ST MARYS FREIGHT HUB

RESPONSE TO SUBMISSIONS

PREPARED FOR:
PACIFIC NATIONAL

OCTOBER 2019

FIGURE 20 UPDATED – STORMWATER LAYOUT - PHASE 1

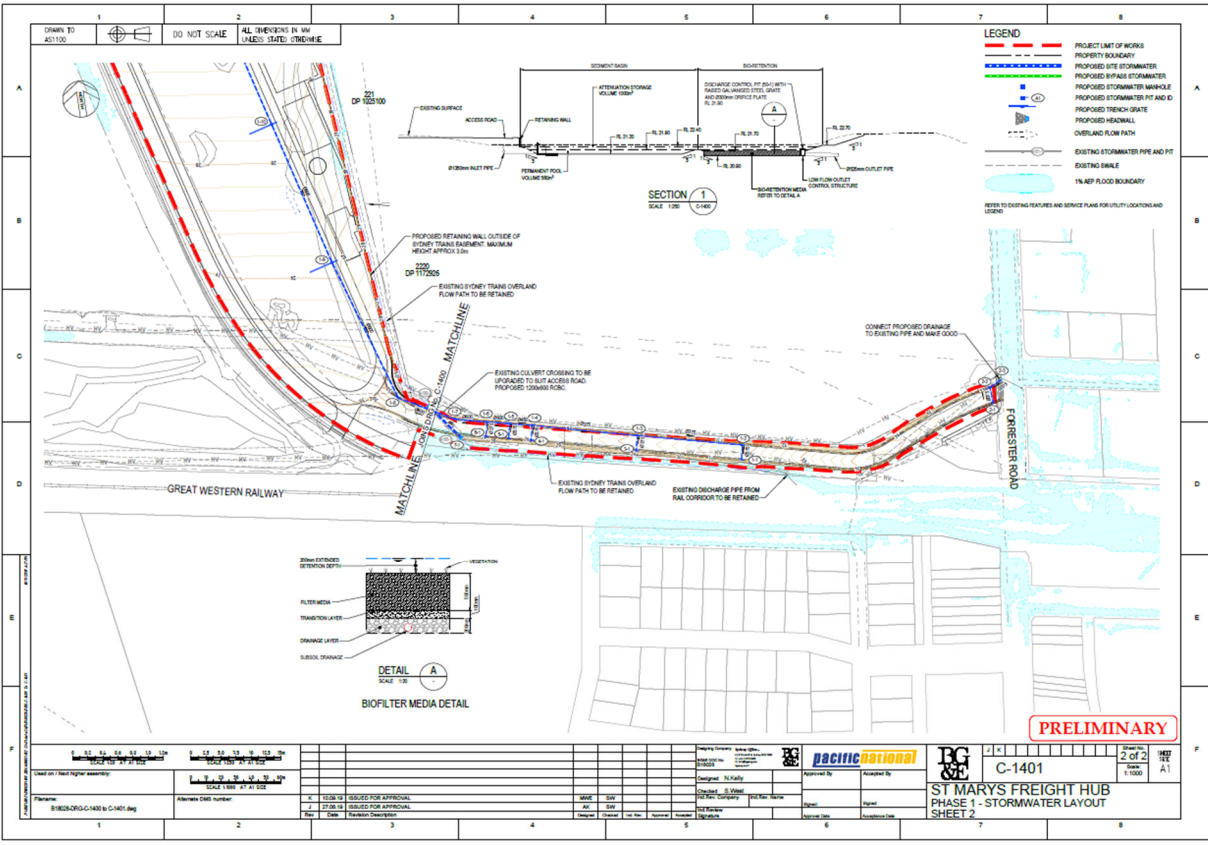
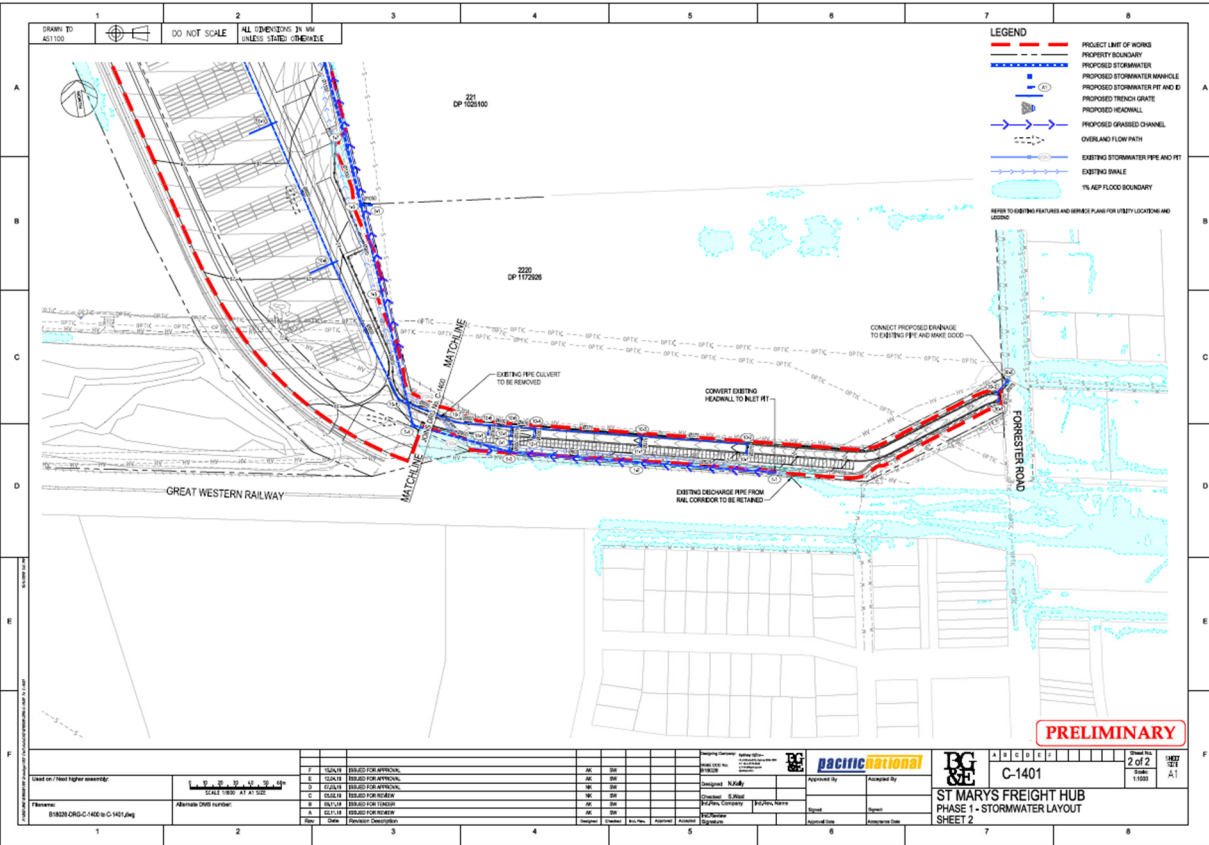
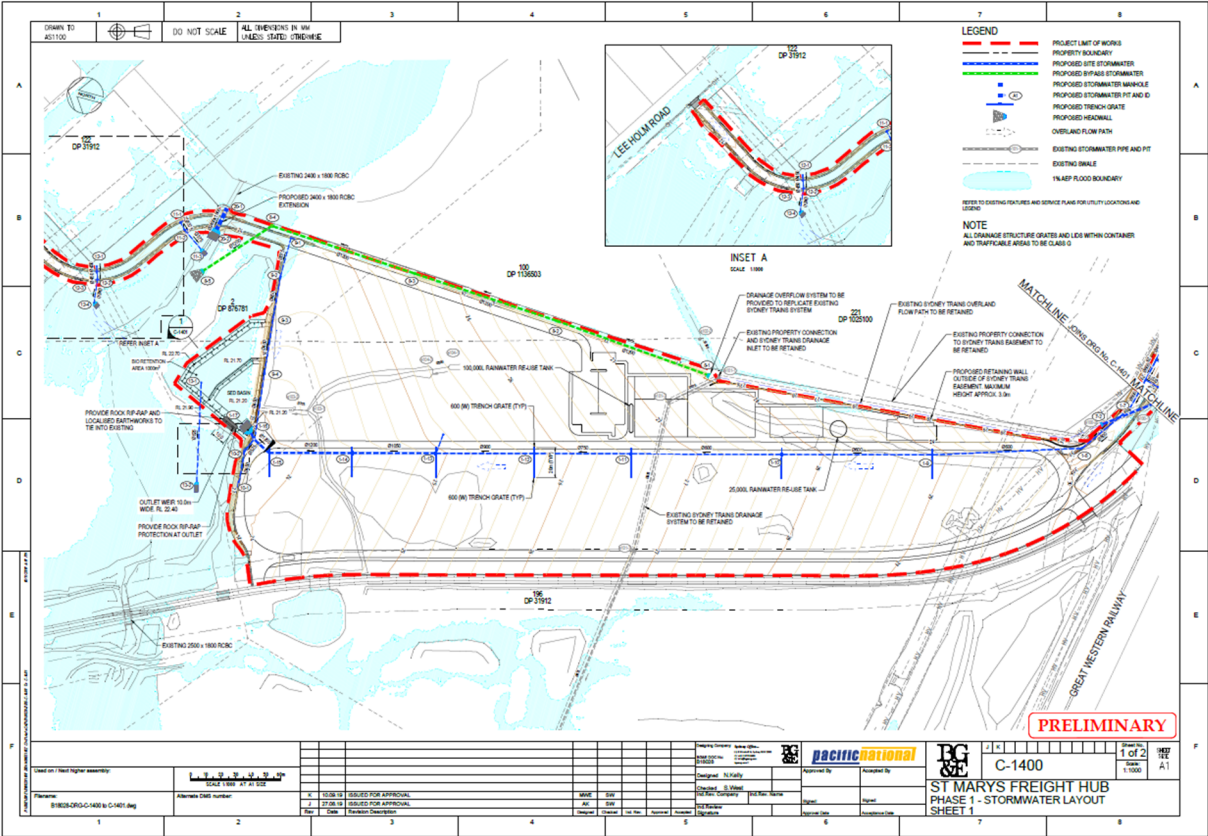
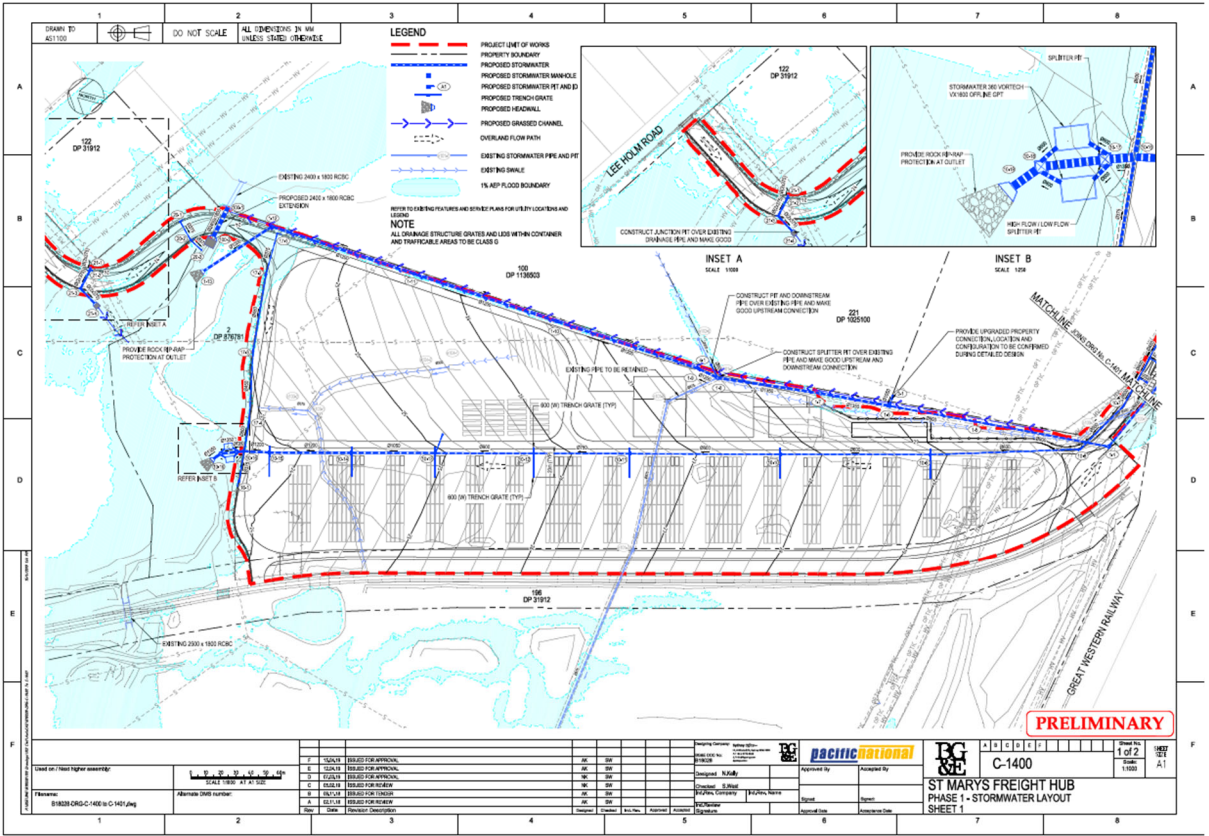
Figures 19 and 20 below, illustrate the proposed changes to the stormwater layout of the proposed development. Refer to Appendix 6 – Stormwater Management Plan.

FIGURE 22 UPDATED – 1% AEP 2 HOUR STORM HYDROGRAPH

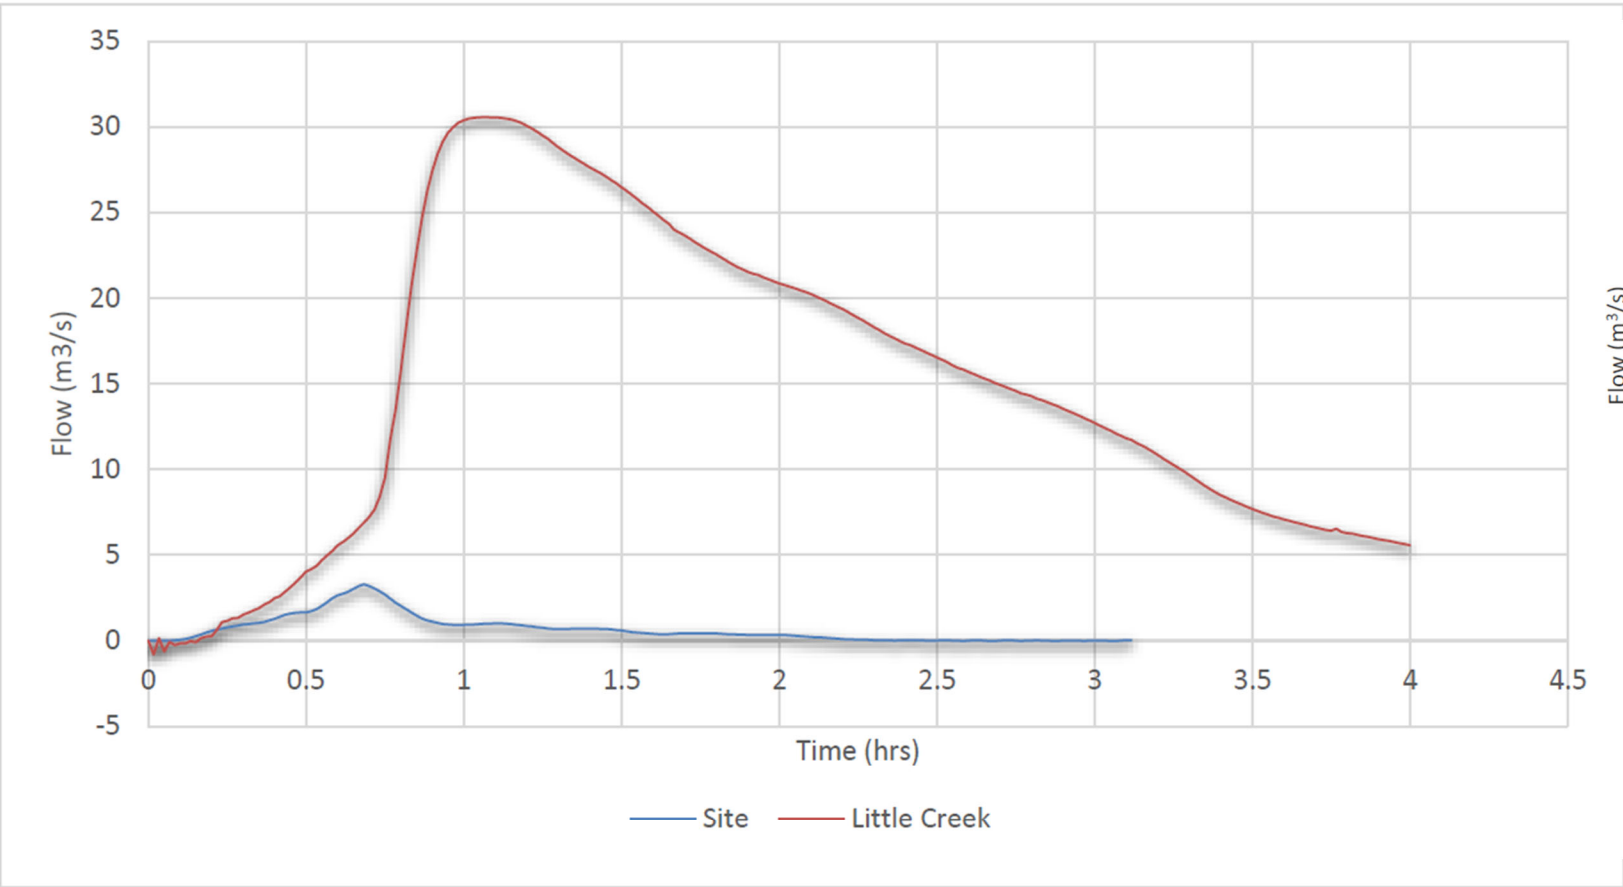
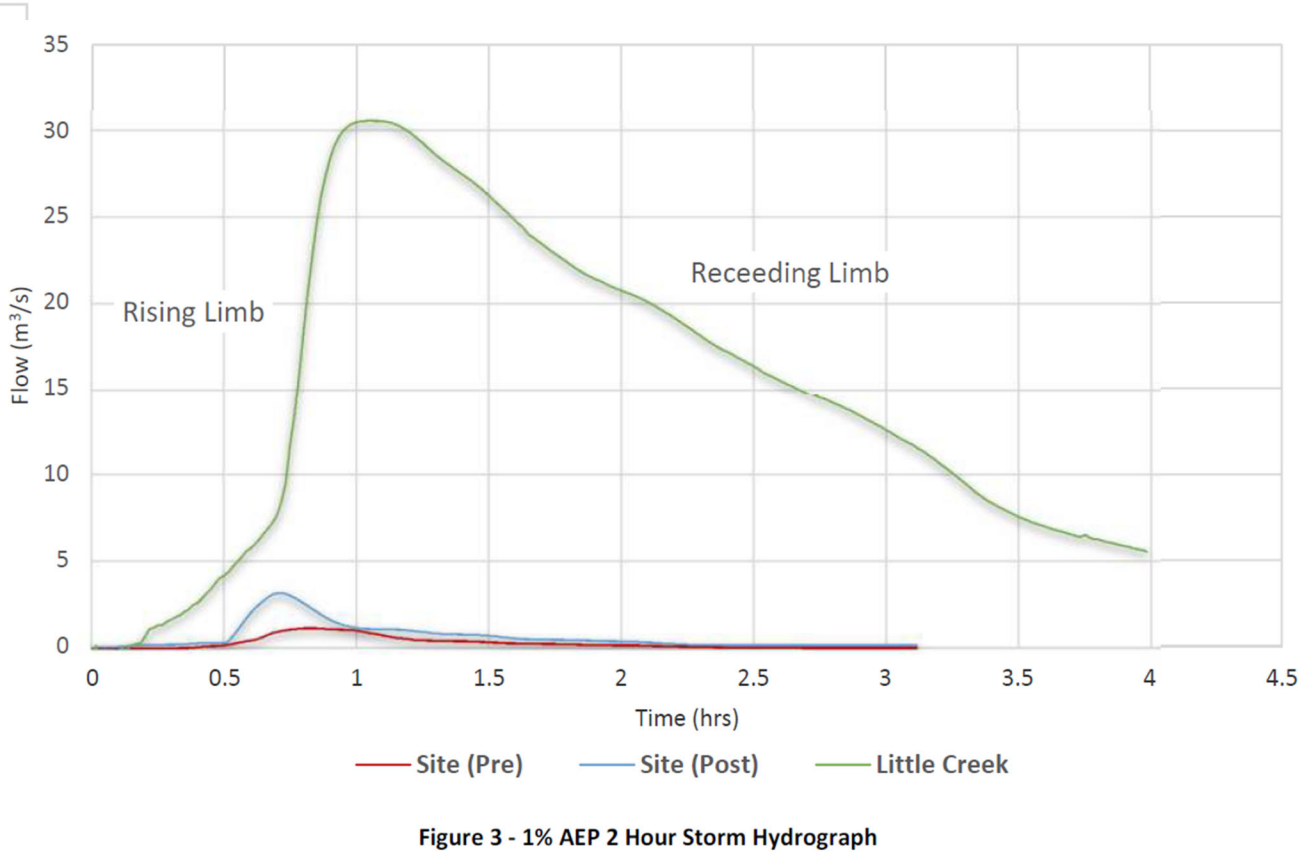
Figures 21 and 22 below, illustrate the exhibited and updated 1% Annual Exceedance Probability (AEP) hydrograph for a 2 hour storm event. Refer to Appendix 6 – Stormwater Management Plan.

FIGURE 24 UPDATED – FLOODING IMPACT ASSESSMENT

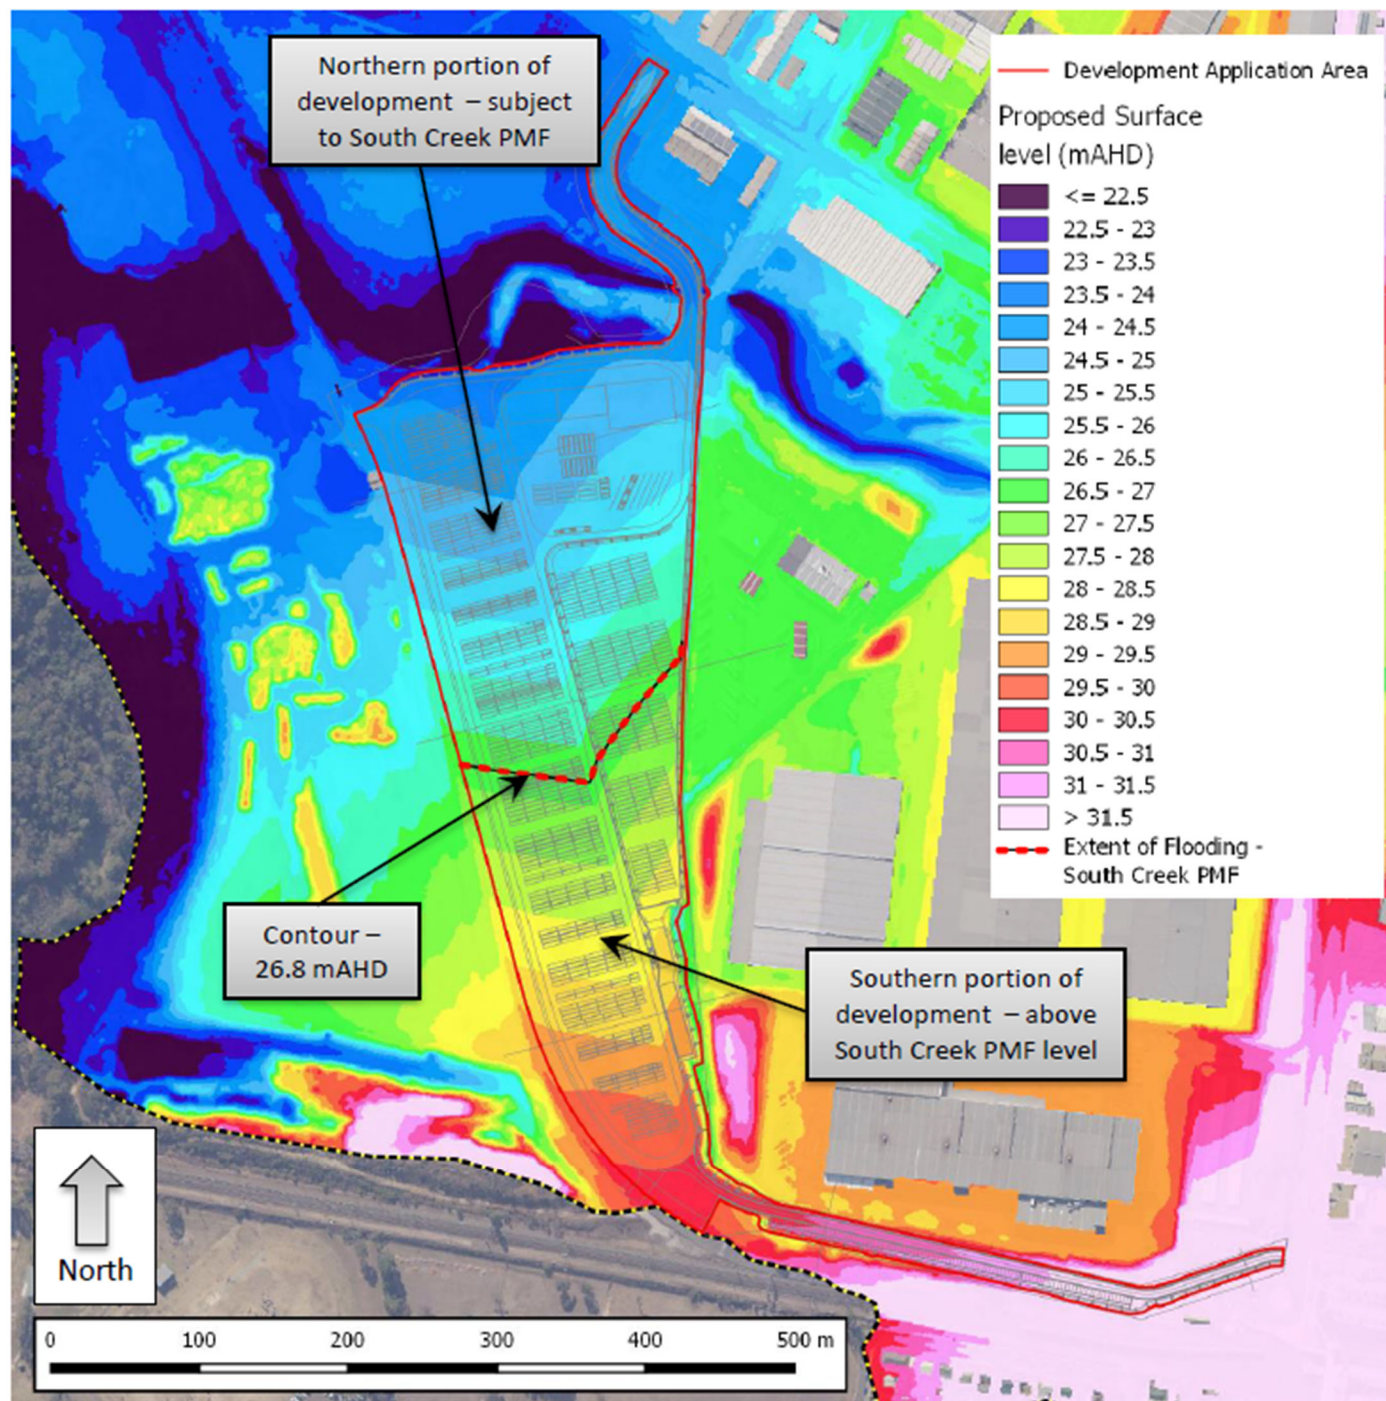
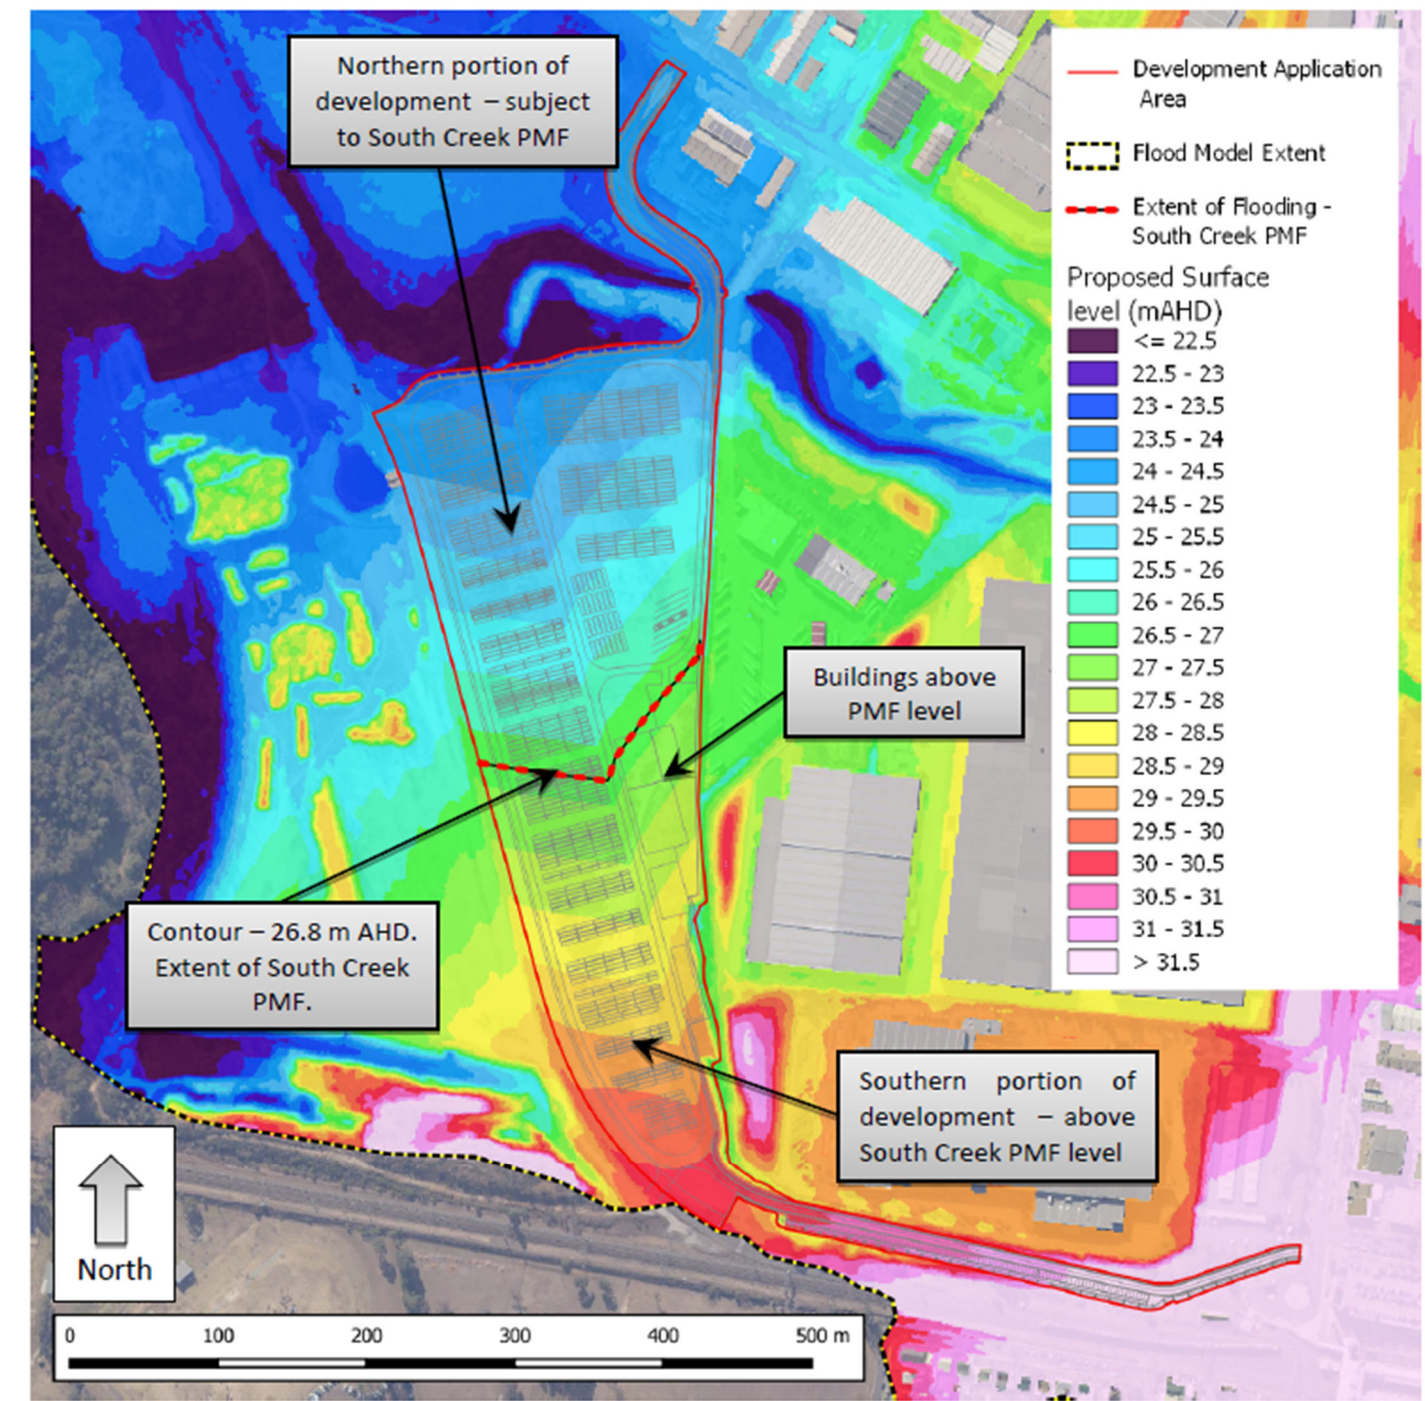
Figures 23 and 24 below, illustrate the exhibited and updated PMF levels. Refer to Appendix 8 – Flood Impact Assessment.
